**Project: South Battery Park City Resiliency Project:  
Pier A Plaza / Battery Site Work and Near  
Surface Isolation (“NSI”) Construction Services  
(the “Project”) Request for Proposals (“RFP”)**

**Date: February 3, 2023**

**RE: Addendum #8  
# of Pages: 31**

MT401

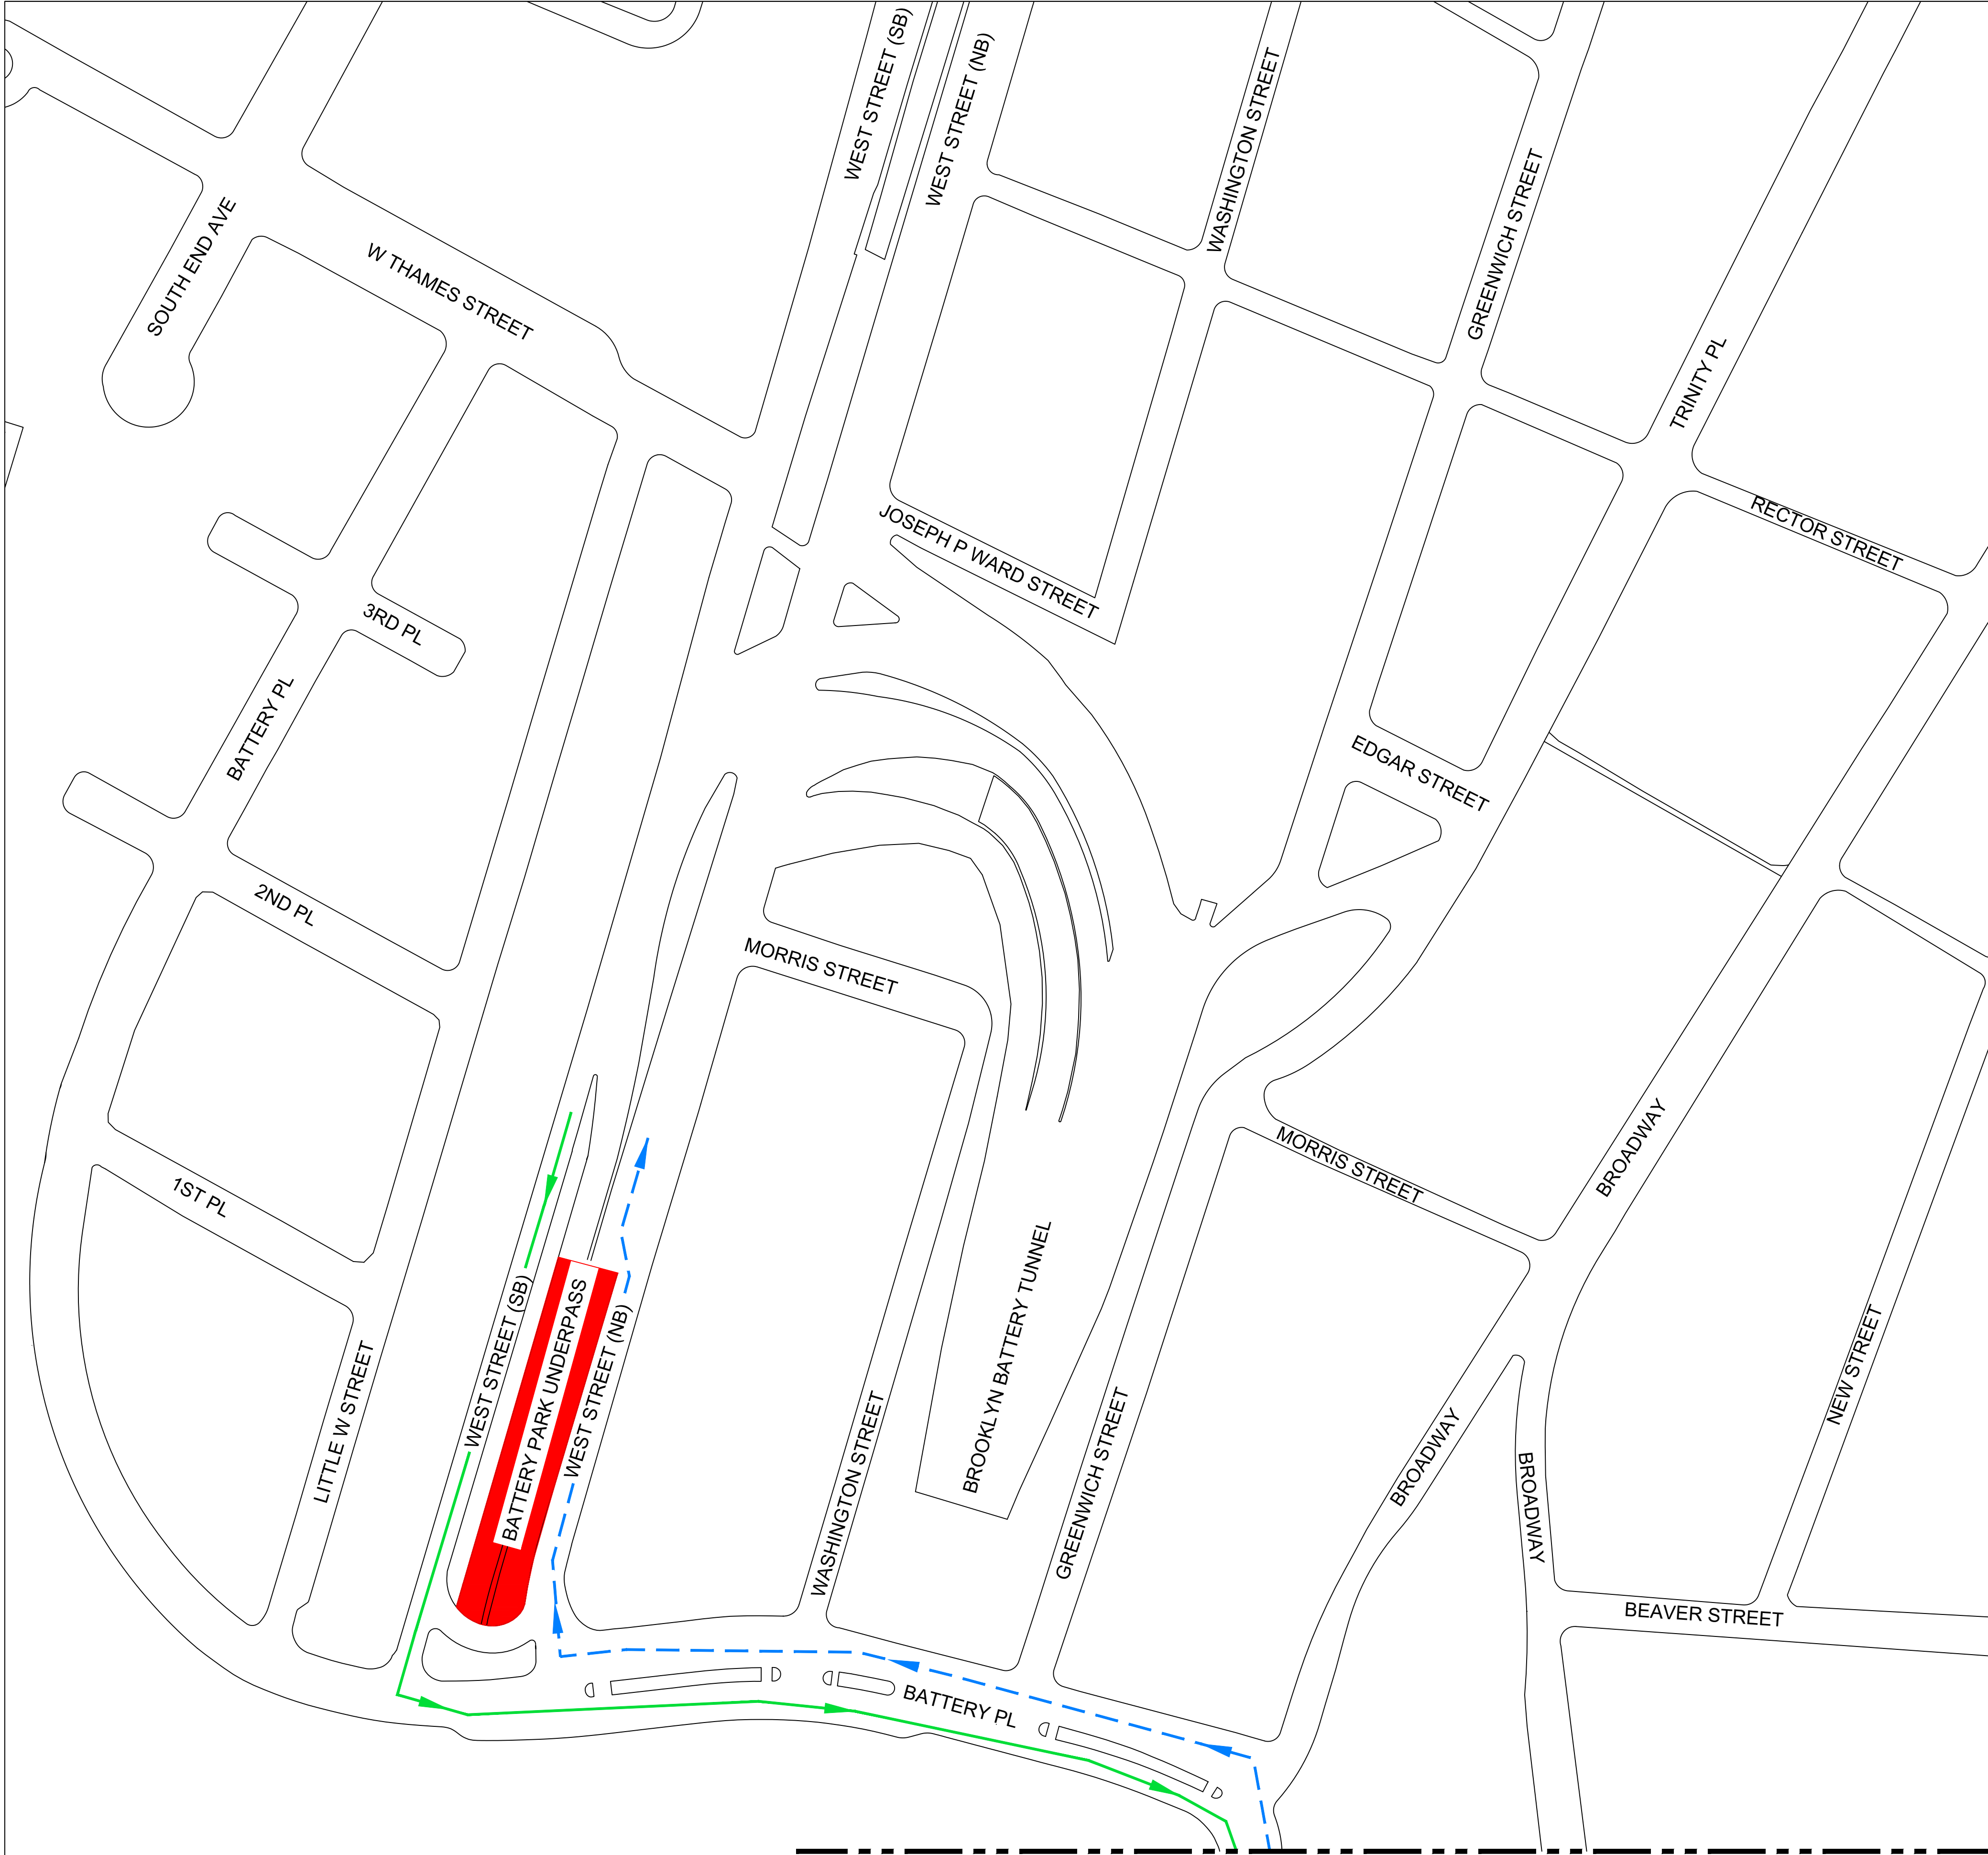
*MT401: Battery Park Underpass Closure Detour Plan 1 of 2*

- TEMPORARY CLOSURE OF THE SB ENTRANCE AND THE NB EXIT TO THE BATTERY PARK UNDERPASS IS ANTICIPATED TO BE REQUIRED. PER NYSDOT, CLOSURE OF THE BATTERY PARK UNDERPASS IS TO OCCUR AT NIGHT.
- THE SUGGESTED DETOUR ROUTES SHOWN ARE SCHEMATIC AND HAVE NOT BEEN APPROVED BY NYCDOT/ NYSDOT. THE CONTRACTOR SHALL DEVELOP AND SUBMIT FINAL MPT AND DETOUR PLANS TO NYCDOT AND NYSDOT DETAILING ROAD CLOSURE AND DETOUR ROUTES, INCLUDING REQUIRED BARRIERS AND SIGNAGE, TO OBTAIN NYCDOT OCMC AND NYSDOT APPROVAL AND PERMITS.
- THE CONTRACTOR SHALL FOLLOW ALL NYCDOT AND NYSDOT REQUIREMENTS AND GUIDELINES.

MT402

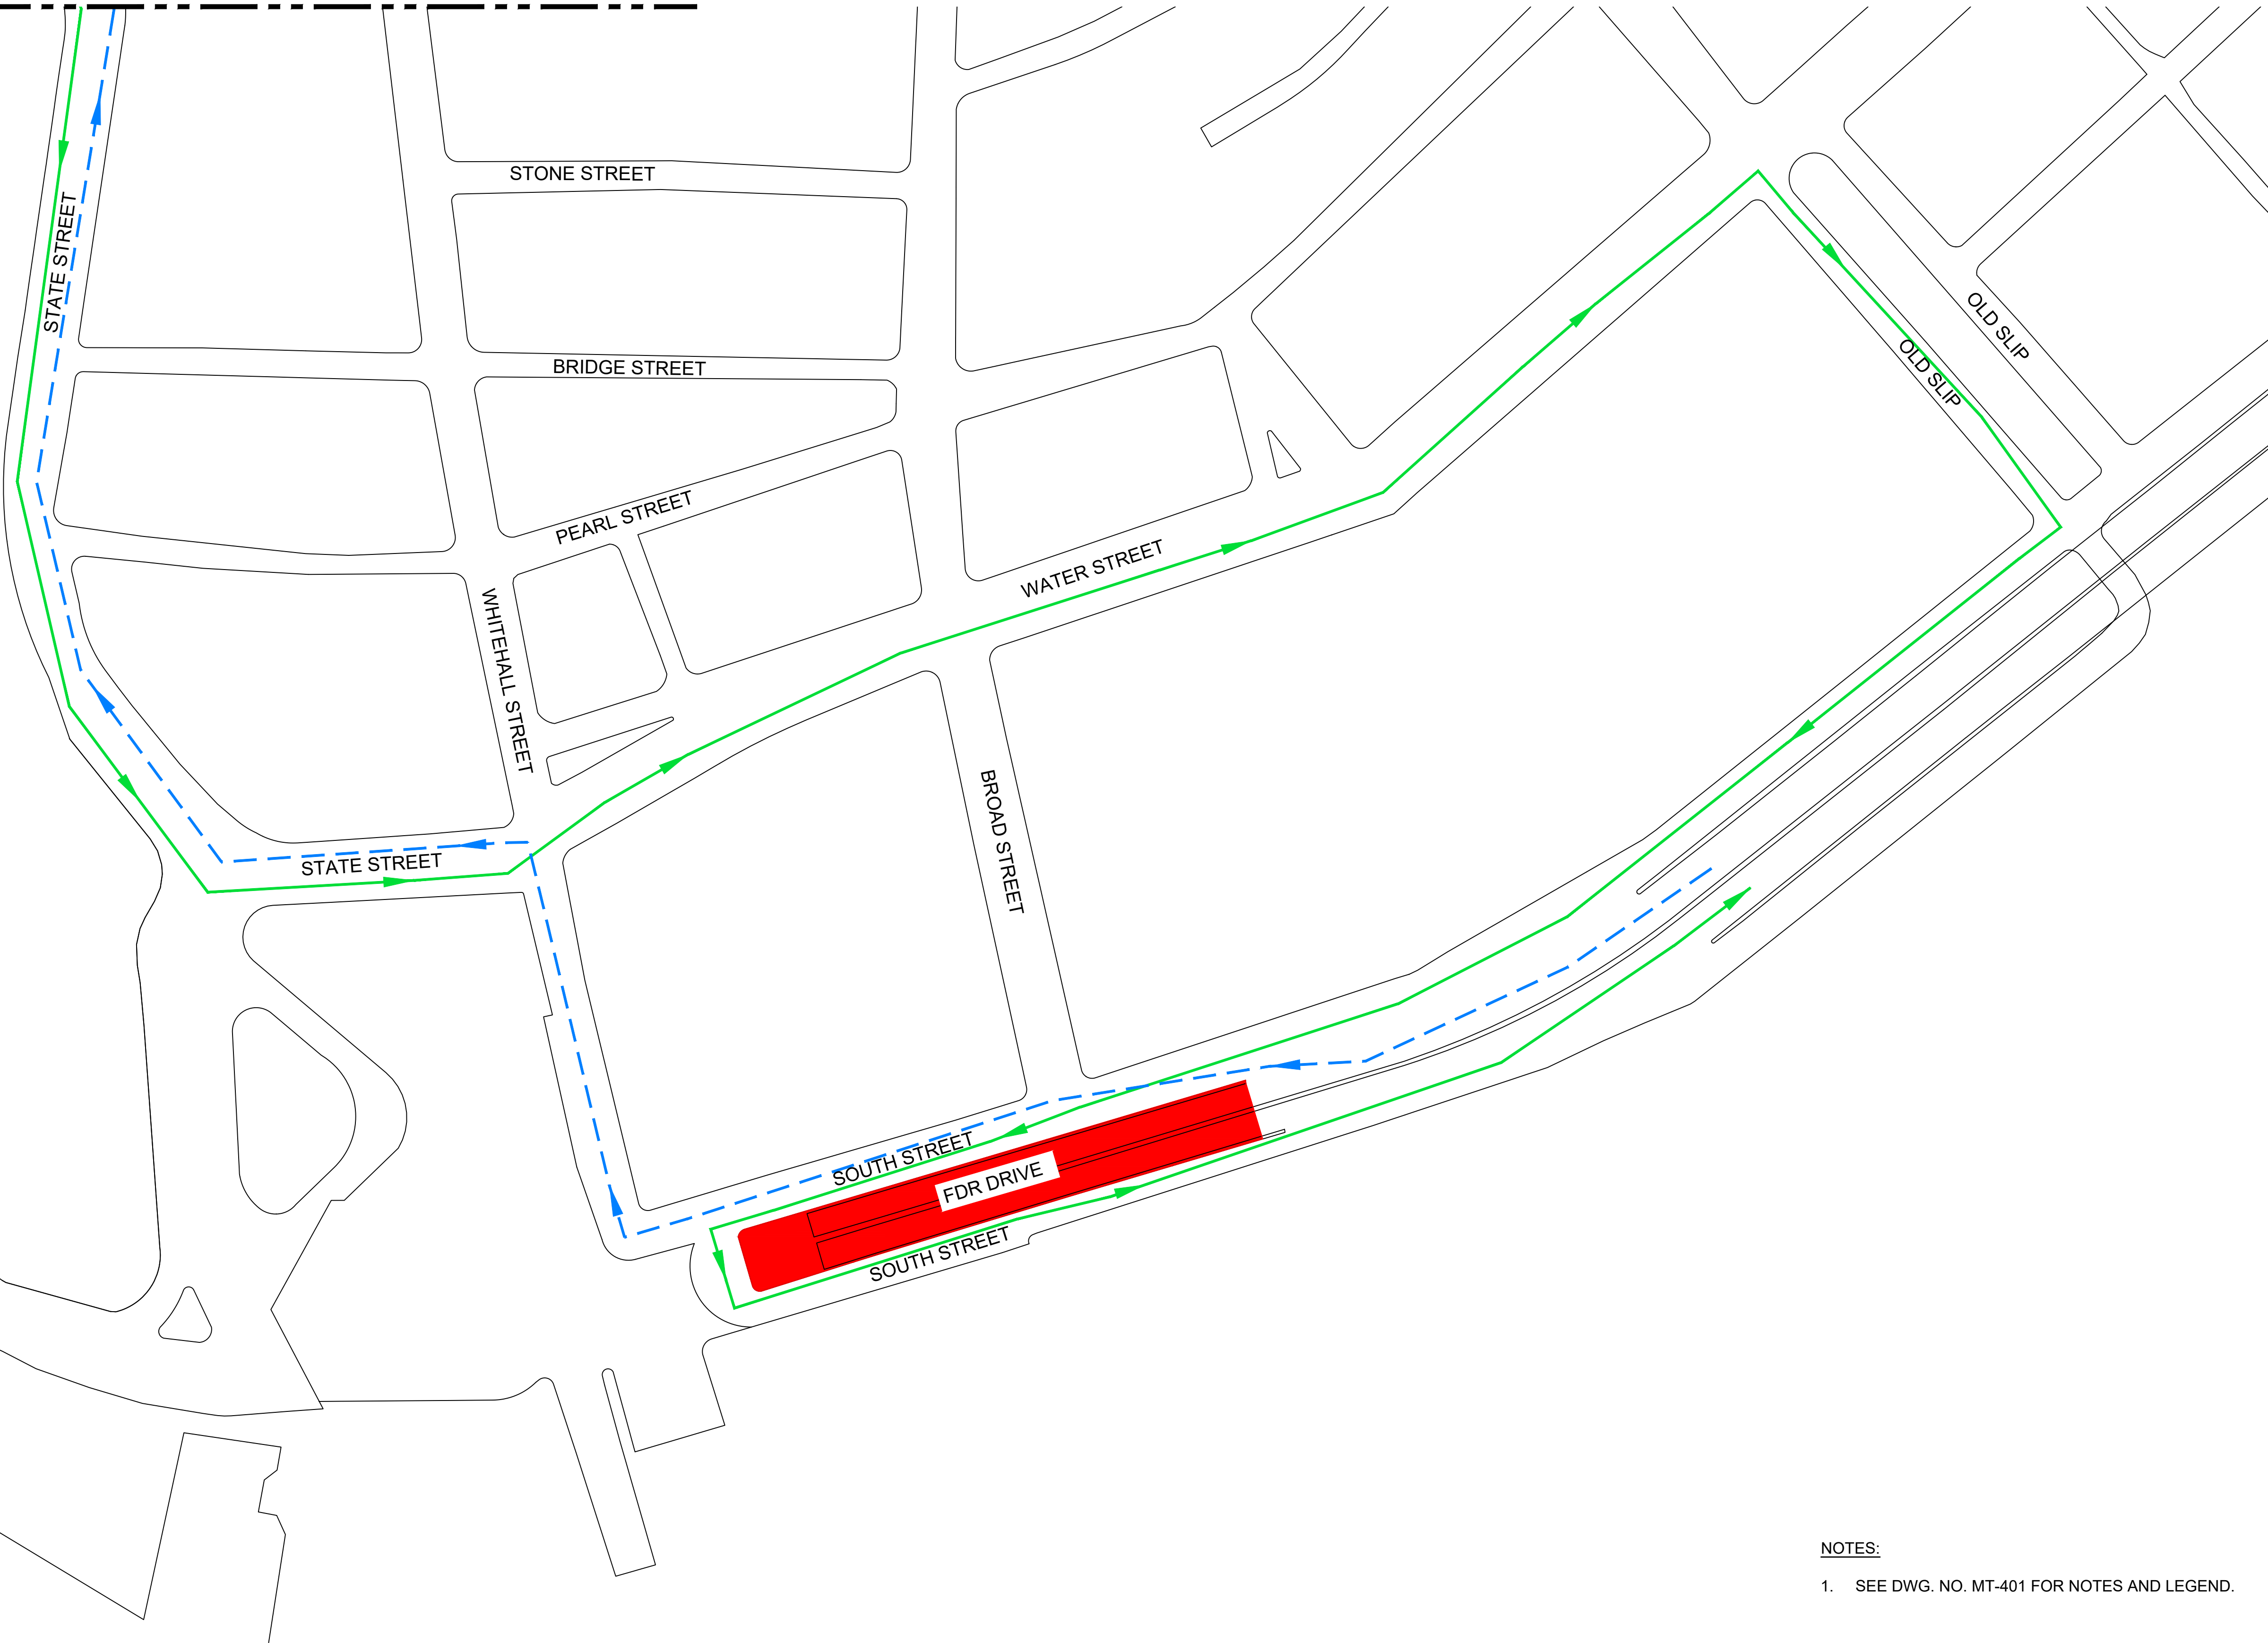
*MT402: Battery Park Underpass Closure Detour Plan 2 of 2*
